***Record of Decision
Holden Mine Site
Chelan County, Washington***

***Prepared by
USDA Forest Service***

RECORD OF DECISION

**THE HOLDEN MINE SITE
CHELAN COUNTY, WASHINGTON**

Groundwater Concentrations and Railroad Creek Stream Conditions East of Tailings Pile 3

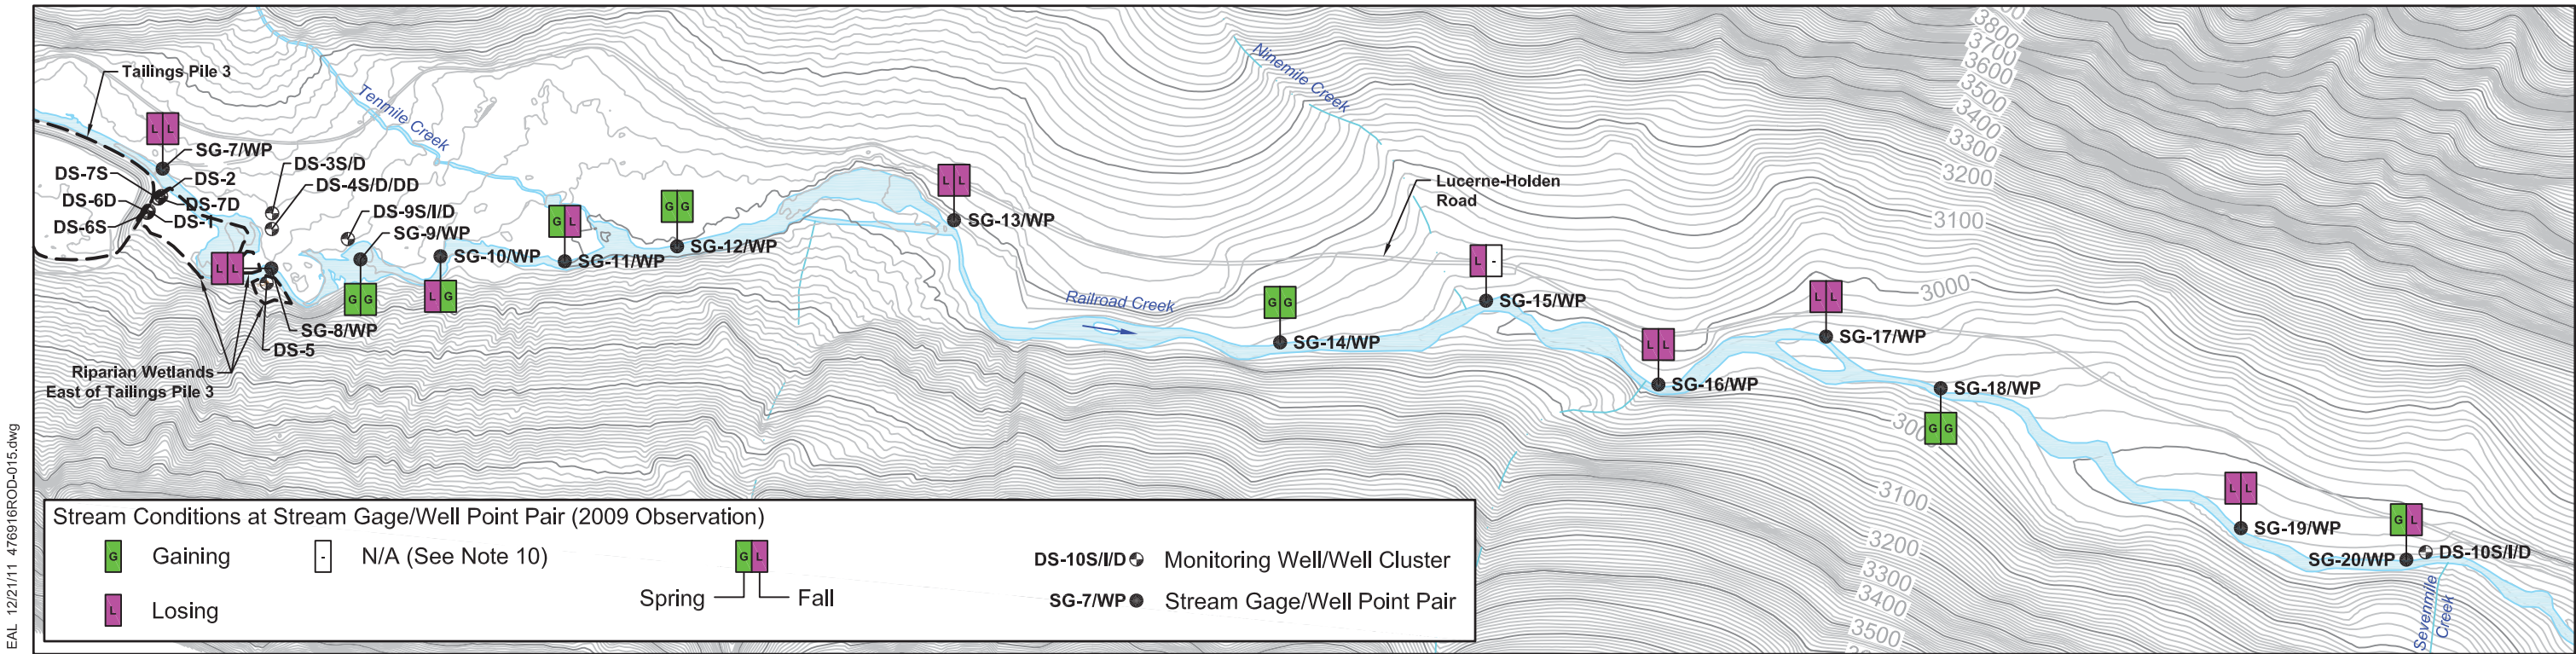
The relocated reach of Railroad Creek north of the tailings piles could be hydraulically isolated to prevent groundwater base flow from conveying hazardous substances into the creek, but this would not protect Railroad Creek downgradient (east of Tailings Pile 3) of this engineered reach, as indicated on Figure 9 of the ROD.

- Available data suggest that Railroad Creek is in a losing condition adjacent to most of Tailings Piles 2 and 3. However, groundwater impacted by releases from the tailings piles enters Railroad Creek downstream of Tailings Pile 3, where the creek is in a gaining condition, at concentrations above cleanup levels; see Figure 9 of the ROD.

Principal Components of Selected Remedy

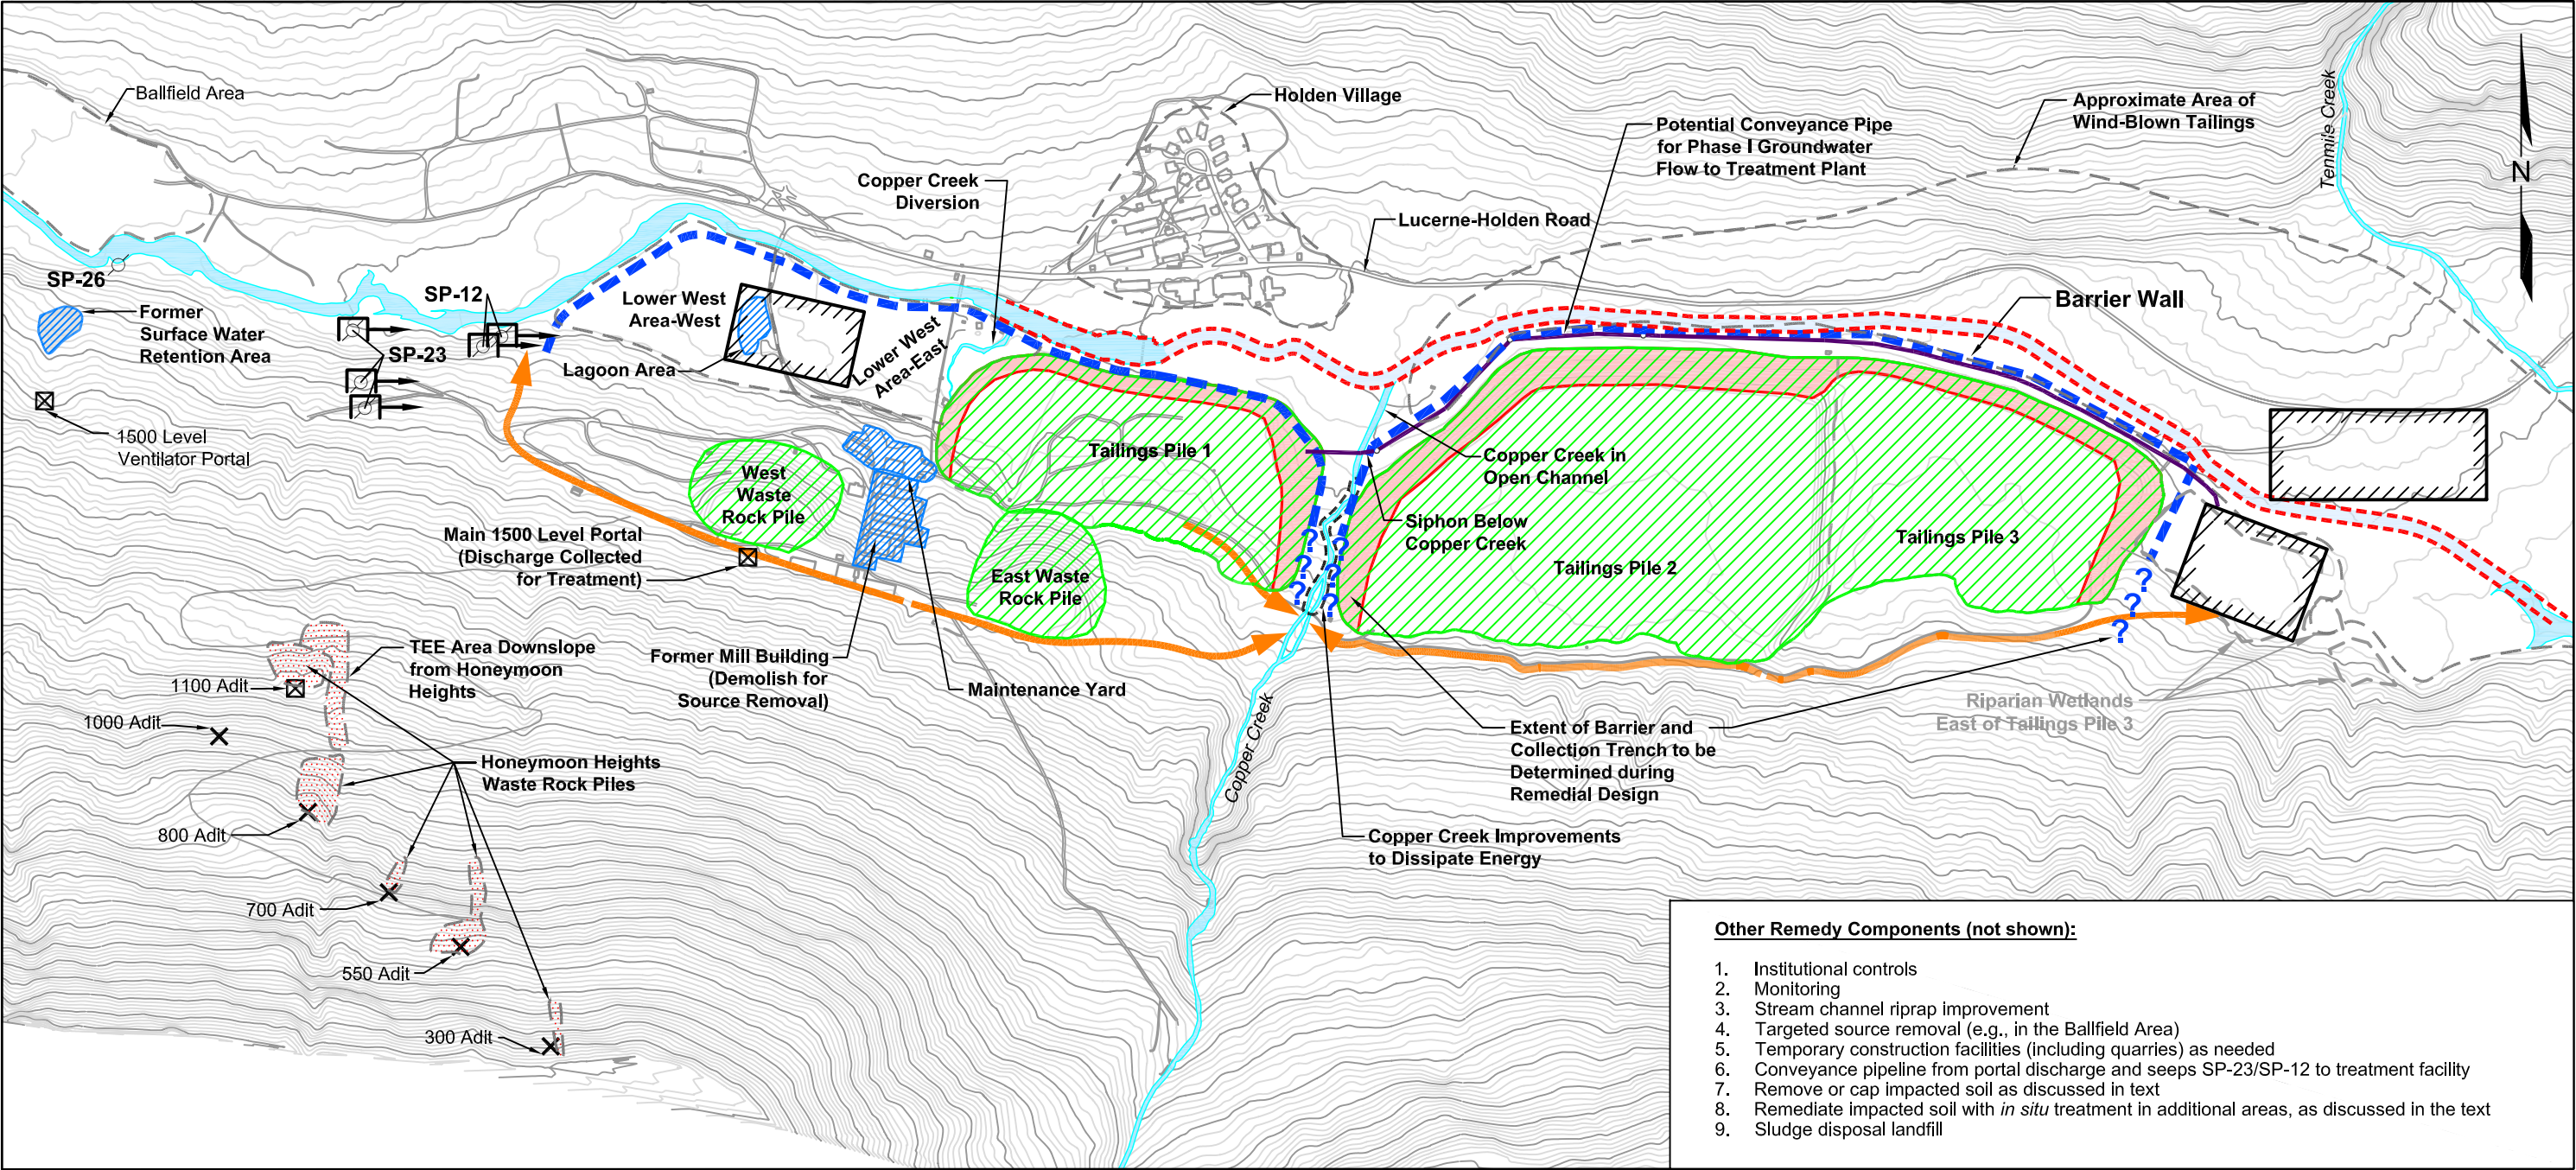
Figure 12 (of the Proposed Plan) should include a note stating that depictions of the areas for moving the toe of the tailings are approximate and the final areas and locations will be determined during Remedial Design.

The Agencies agree; Figure 18 of the ROD indicates the anticipated limits of the Railroad Creek realignment and regrading slopes of the tailings piles will be determined during Remedial Design. Areas in which the toe of the tailing piles will be moved will be finalized during Remedial Design.
